Access Compliance Report

Public Rights-of-Way

Intersection ID: 14827	Main Street: PIERCE_ST	Cross Street: WAVERLY_AV	Location: W
ADA ID: DAFC82607EA0	Ramp Type: PerpDiag	Initial Pass/Fail: Fail	Overall Compliance: No
		Severity Score: 12.5

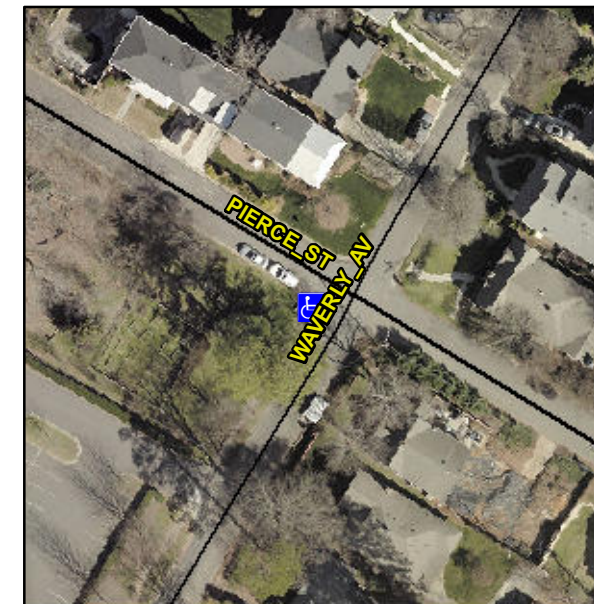
Not Found, R304.5.3

Compliance	Description	Data	Compliance	Description	Data
N/A	Ramp Length (in)	83.0	Yes	Ramp Slope (%)	8.2
Yes	Ramp Width (in)	48.0	No	Ramp XSlope (%)	5.3
N/A	Flare Type LT	N/A	N/A	Flare Type RT	N/A
N/A	Flare Slope LT (%)	N/A	N/A	Flare Slope RT (%)	N/A
N/A	Flare Traversable LT?	N/A	N/A	Flare Traversable RT?	N/A
N/A	Landing Length (in)	N/A	N/A	DWS Provided?	N/A
N/A	Landing Width (in)	N/A	N/A	DWS Contrast?	N/A
N/A	Landing Slope (%)	N/A	N/A	DWS Length (in)	N/A
N/A	Landing X Slope (%)	N/A	N/A	DWS Full Width?	N/A
N/A	Landing Curb? (Y/N)	N/A	N/A	DWS Offset (in)	N/A
N/A	Shared Landing?	N/A			
N/A	Gutter Ponding?	N/A	N/A	Gutter Slope (%)	N/A
N/A	Gutter Lip Ht (in)	N/A	N/A	Gutter X Slope (%)	N/A
N/A	Painted X Walk1?	No	N/A	Painted X Walk2?	No
	X Walk 1 Direction	To SE		X Walk 2 Direction	To NE
N/A	X Walk 1 Width (in)	N/A	N/A	X Walk 2 Width (in)	N/A
	X Walk 1 Slope (%)	2.0		X Walk 2 Slope (%)	0.9
	X Walk 1 X Slope (%)	2.6		X Walk 2 X Slope (%)	0.8

Remove & Replace Curb Ramp With Two New Directional Ramps or Equivalent.
